Change Order Request

PFAS Well 15

Field Order 11- Curb at Generator Area

FO#11

FOUNDATION PLAN

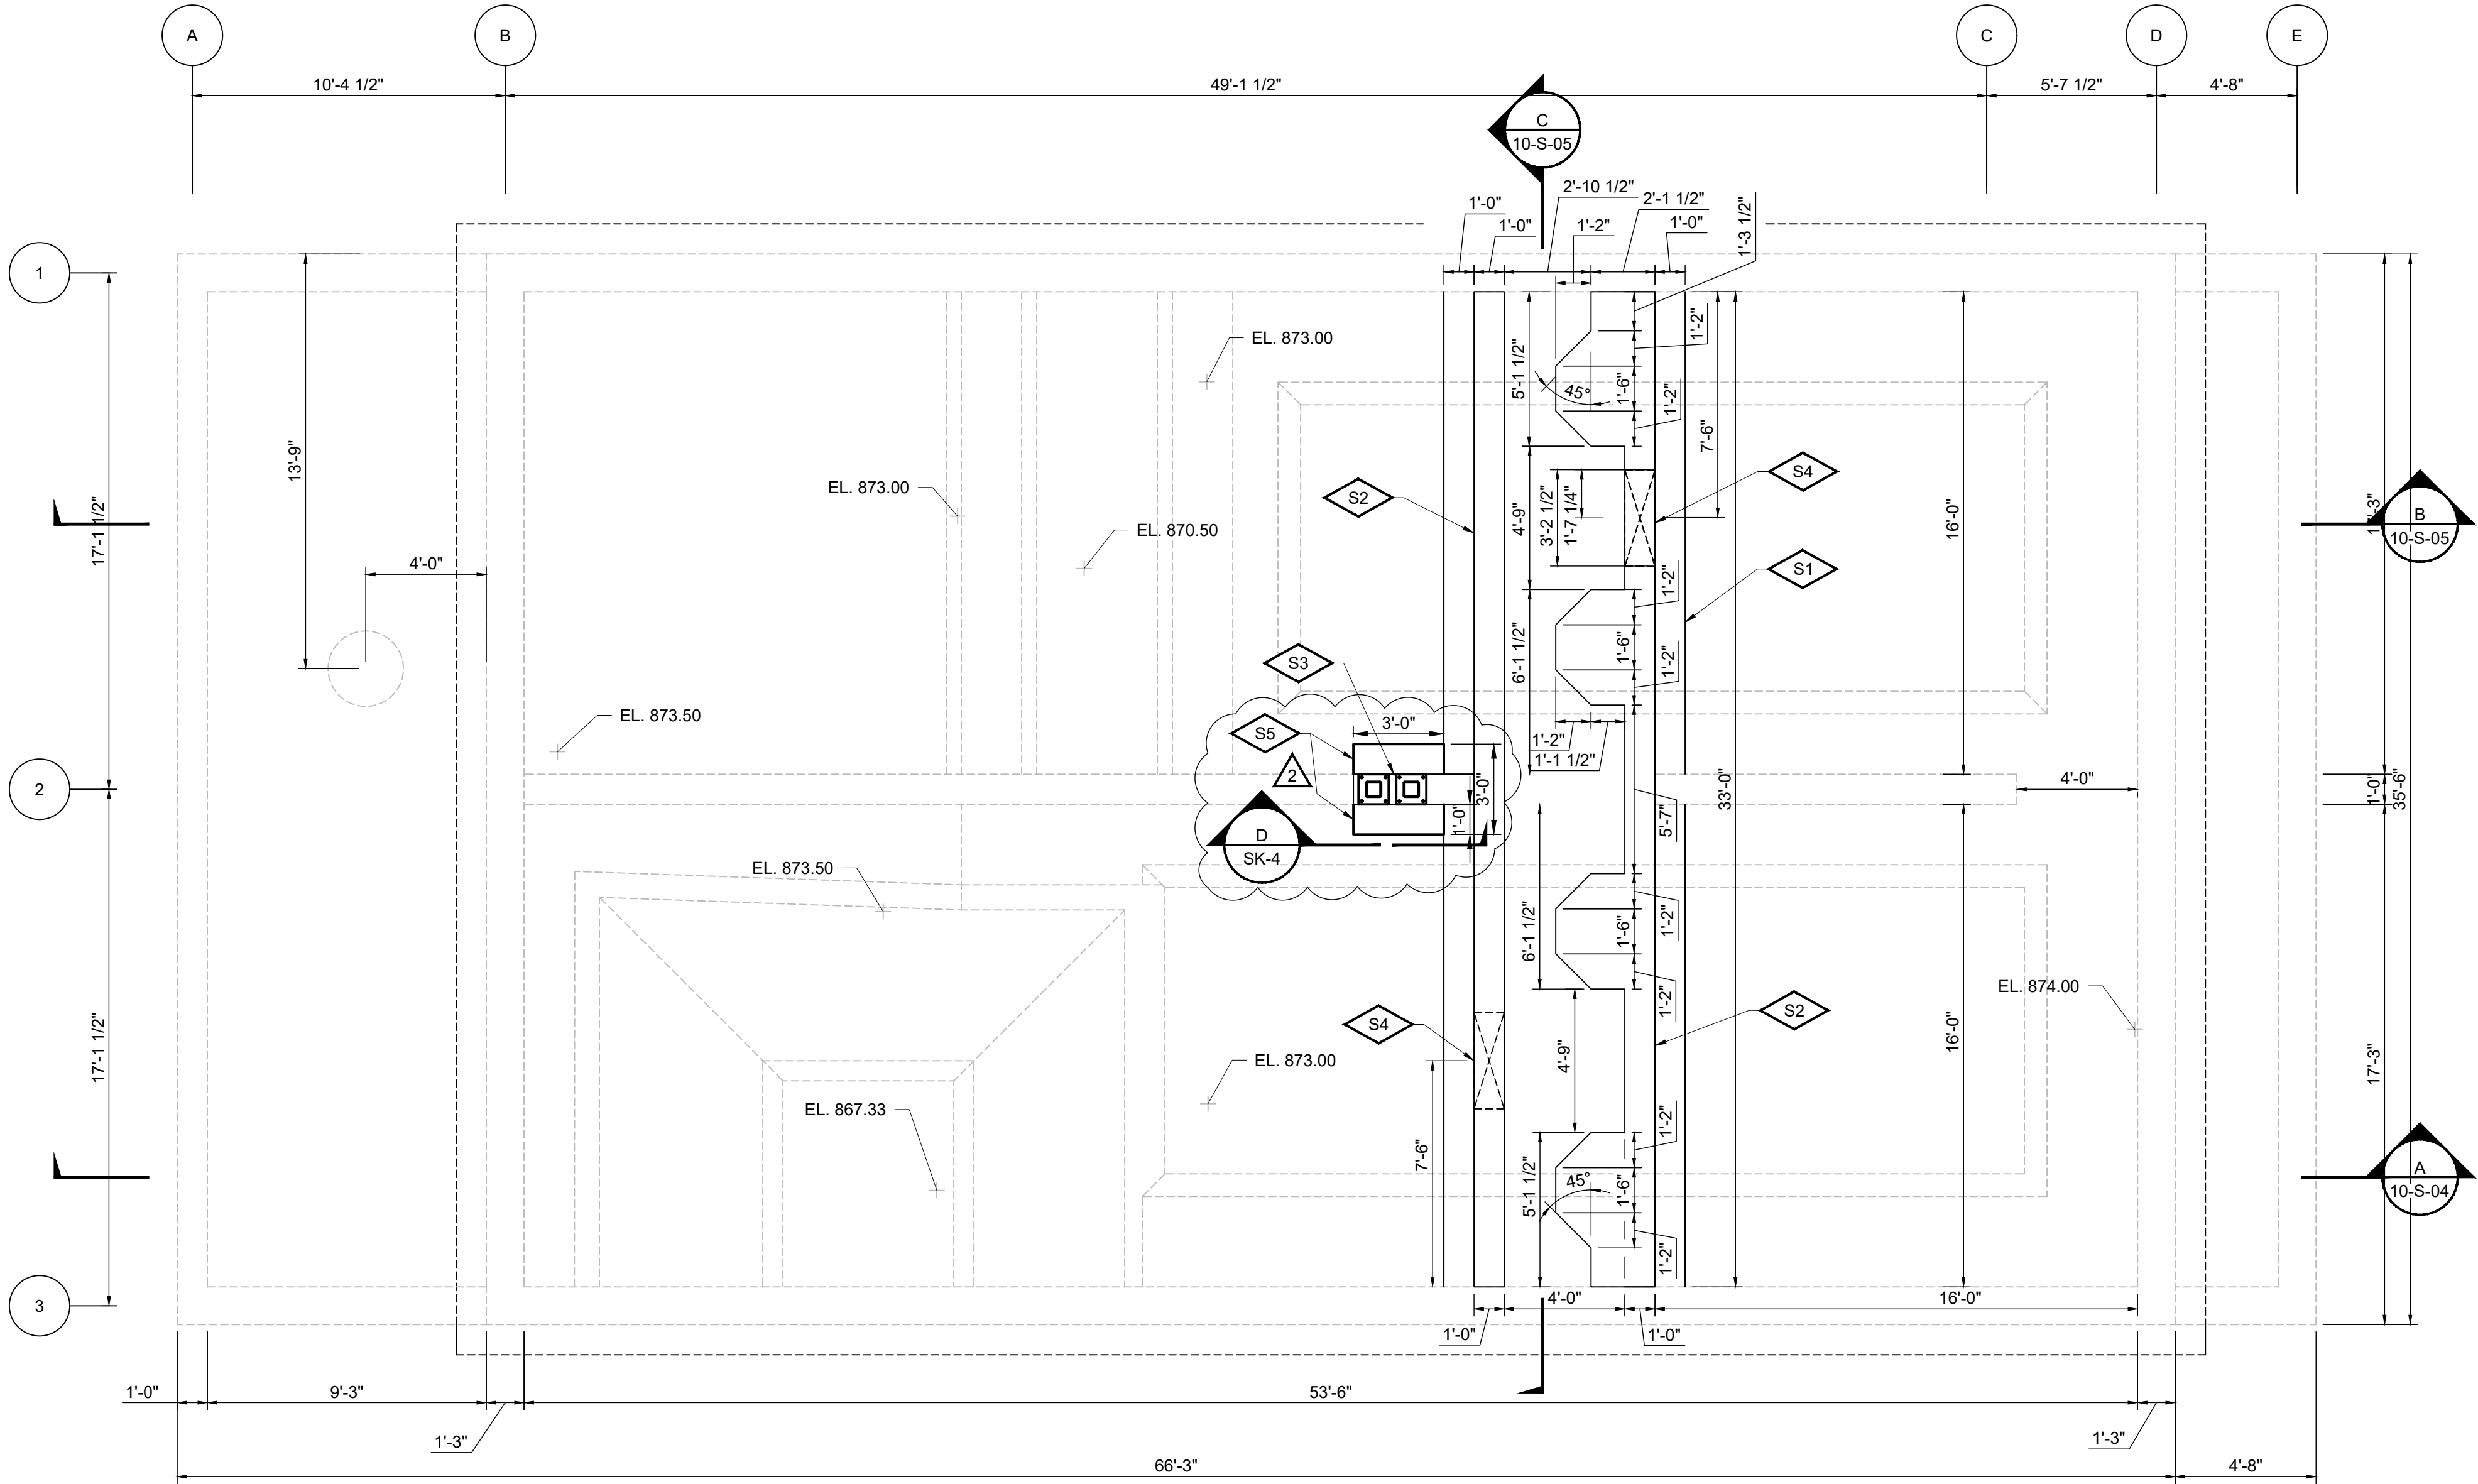
- S1 CONSTRUCT BASE SLAB TO BE PLACED ON TOP OF EXISTING SLAB
- S2 CONSTRUCT 12-INCH CONCRETE WALL
- S3 NEW OPENING IN WALL TO PROVIDE FLOW BETWEEN TANKS
- S4 ACCESS MANWAY OPENING IN WALL. SEE DETAIL SHEET 10-S-06.
- S5 REFER TO DETAILS ON COLUMN AND FOUNDATION. DWG. SK-4. RESPONSE TO RFI #35.

2	10/21/2024	RESPONSE TO RFI #35
1	12/22/23	ISSUE FOR BID
I/R	DATE	DESCRIPTION

SK-4 DRAWING
RESPONSE TO RFI #35

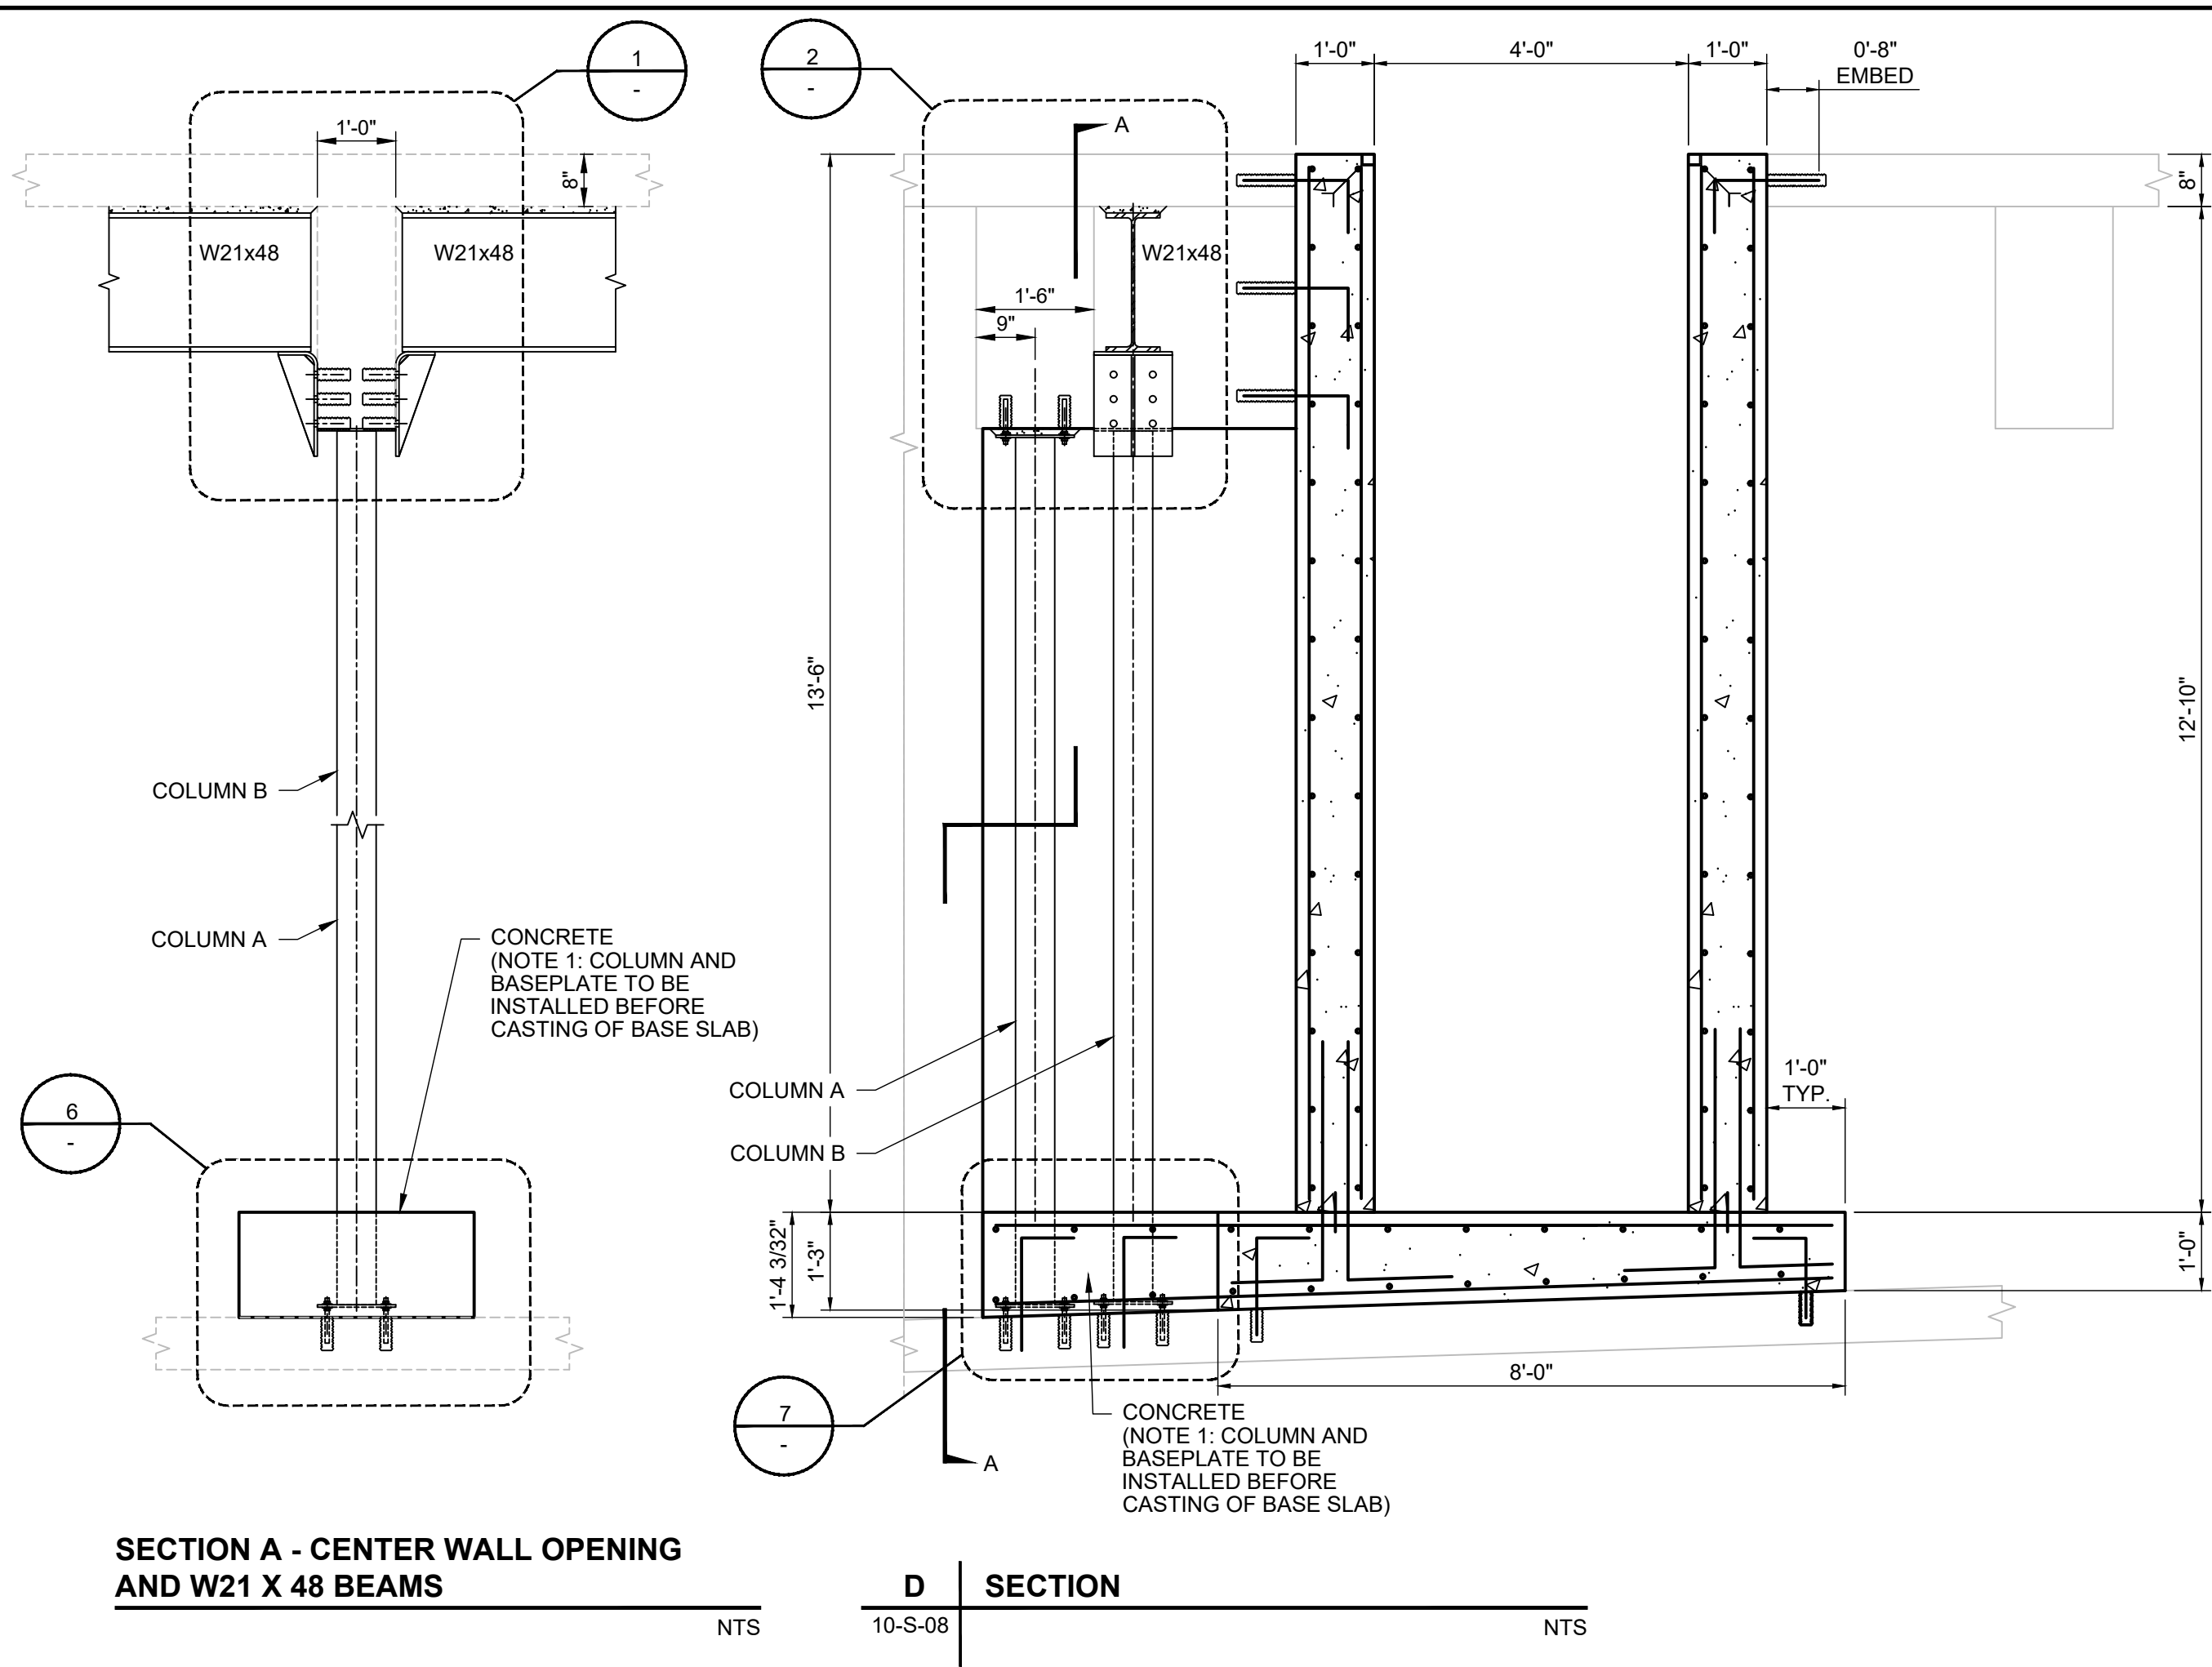
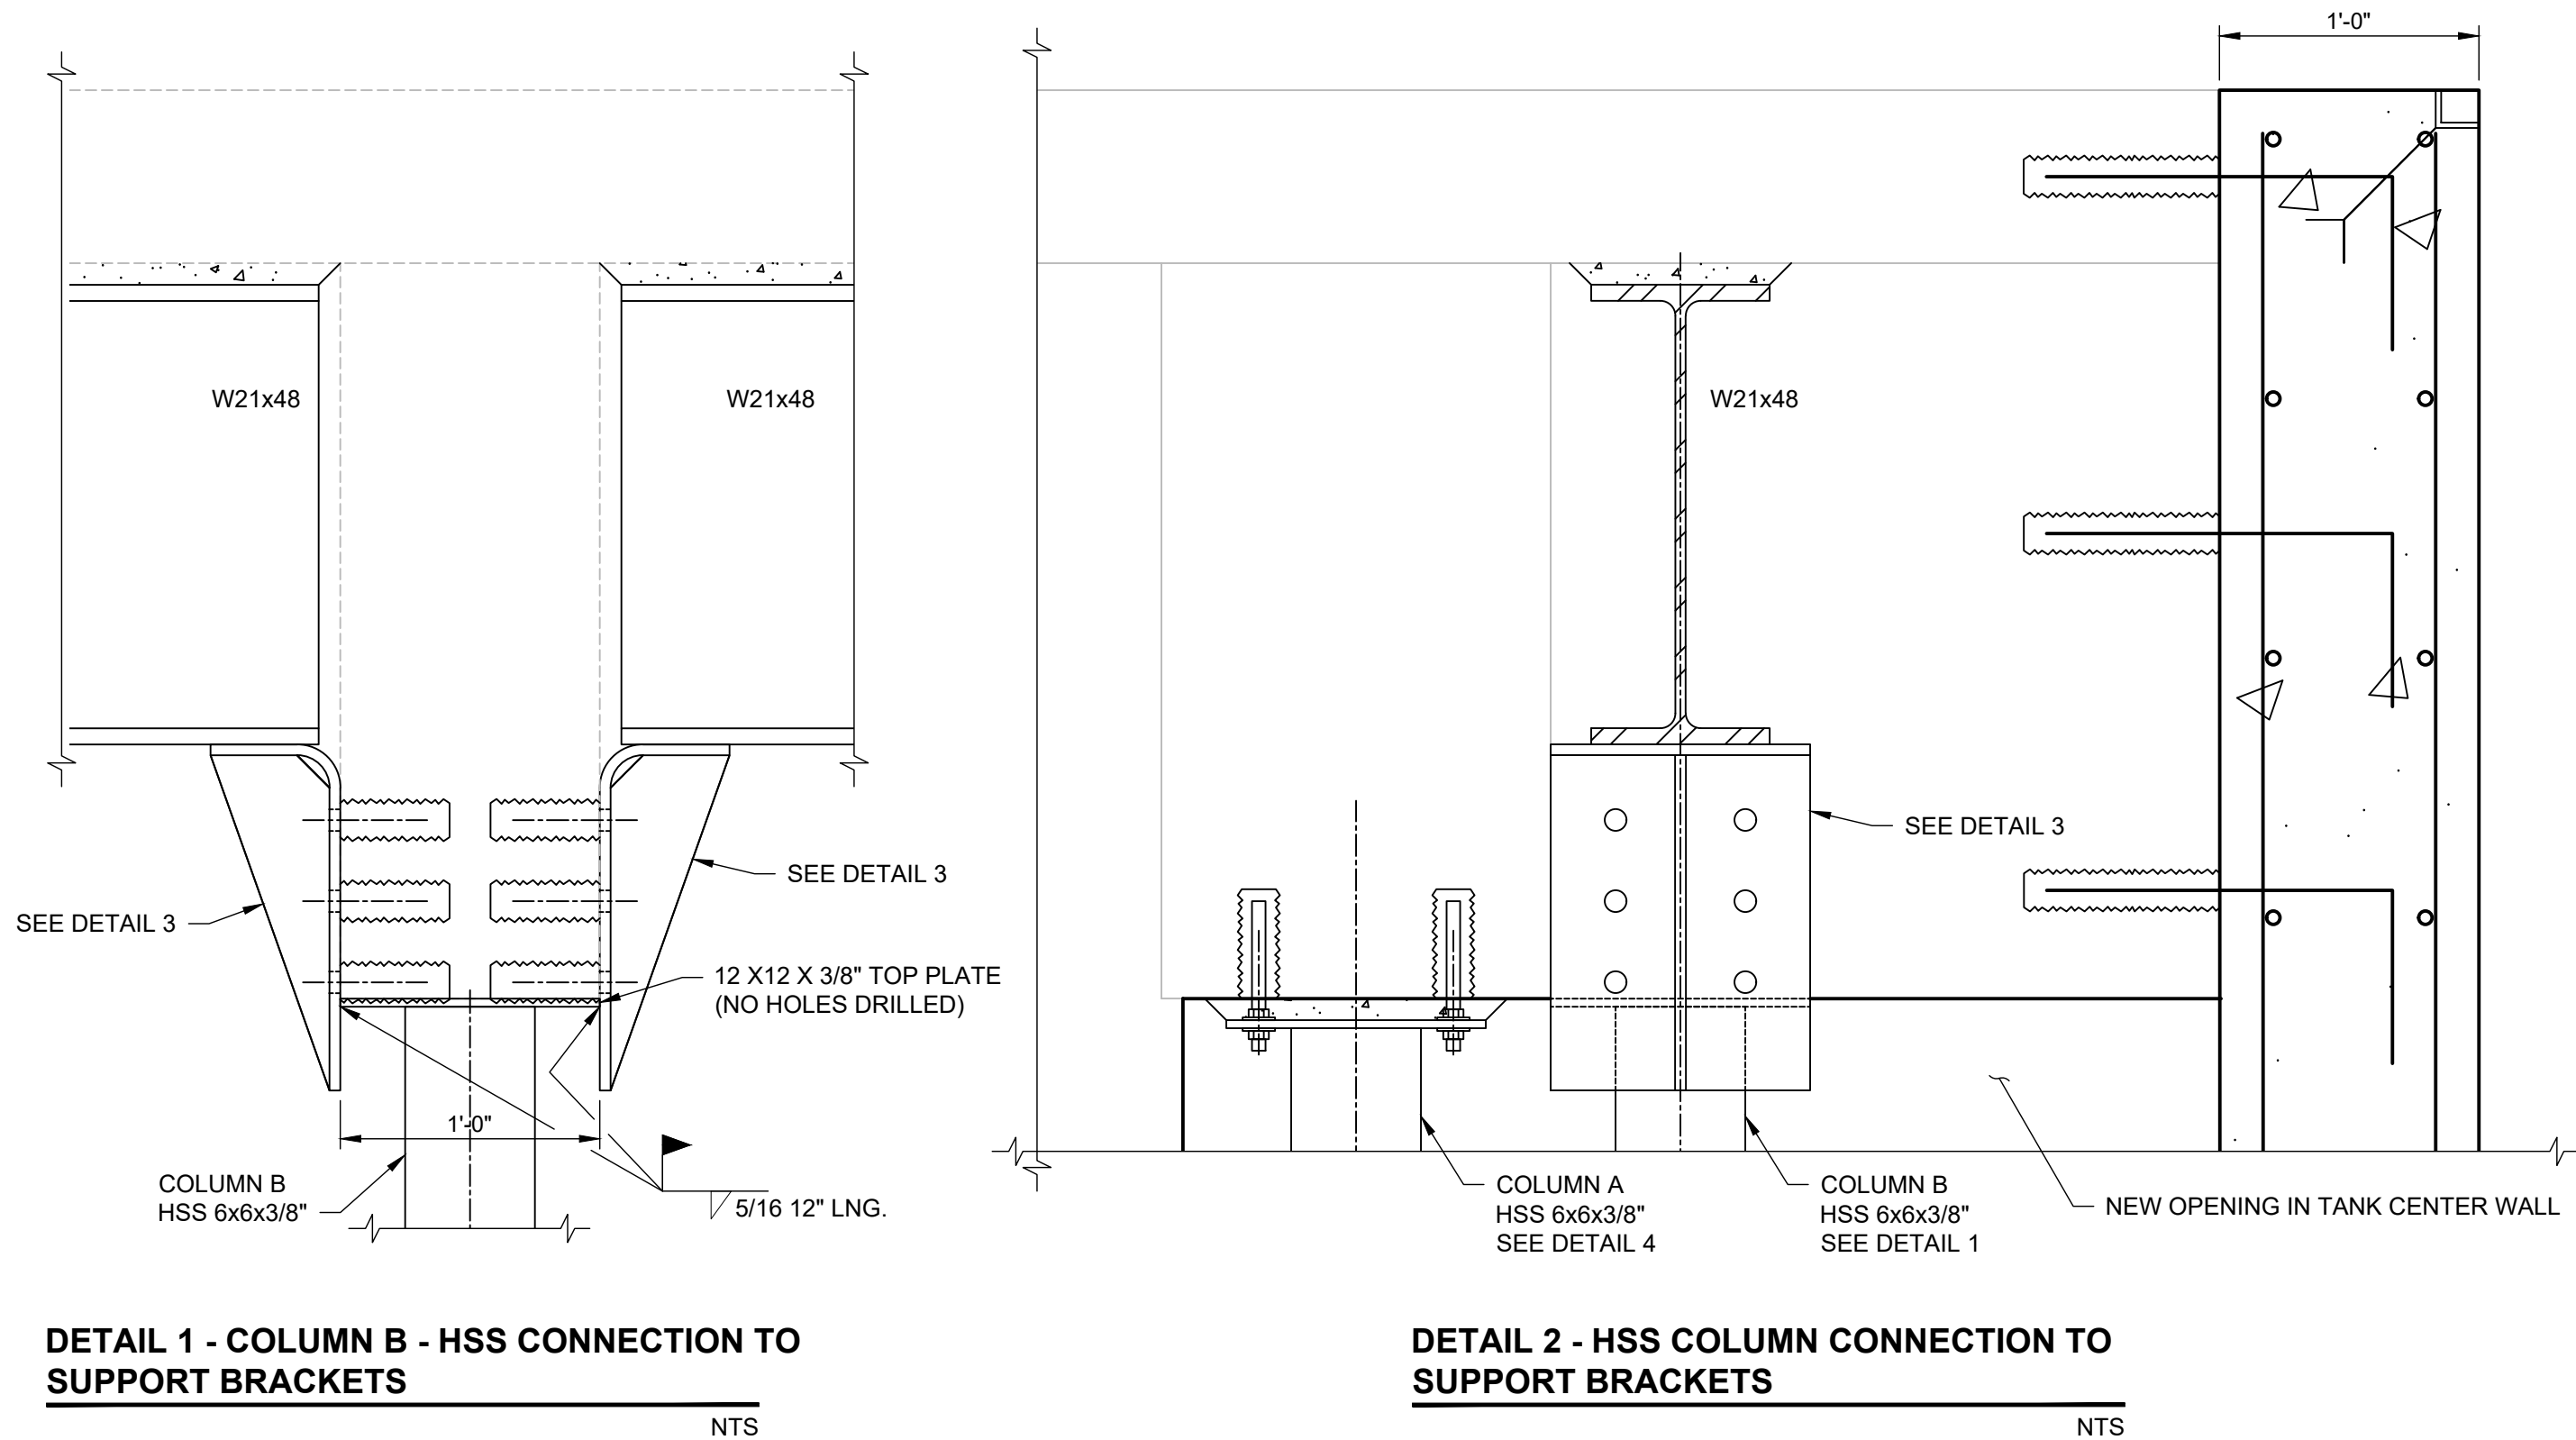
ISSUE/REVISION		
1	10/21/2024	RESPONSE TO RFI #35
I/R	DATE	DESCRIPTION

1. The existing 5 to 6-inch deep sawcuts at the two locations are to be cleaned out and filled with epoxy by gravity feed with resin method in accordance with the manufacturer's recommended installation procedures.
 - a. Reference: American Concrete Institute's' ACI RAP Bulletin 2 – Field Guide to Concrete Repair Application Procedures, Crack Repair by Gravity Feed with Resin.
 - b. Epoxy material shall be Sikadur-32 Hi-Mod manufactured by Sika Corporation or engineer's approved equivalent.
2. Install steel columns as shown on the attached revised drawing Nos. 10-S-01 and 10-S-08, dated 10/21/24 and Sketch SK-4 dated 10/21/2024 to support existing slab and beam floor system. SK-4 will be incorporated into the As-Built drawings when project is completed.
3. Provide cost and schedule impacts, if any, for this work to AECOM and Owner for review prior to commencement of work.
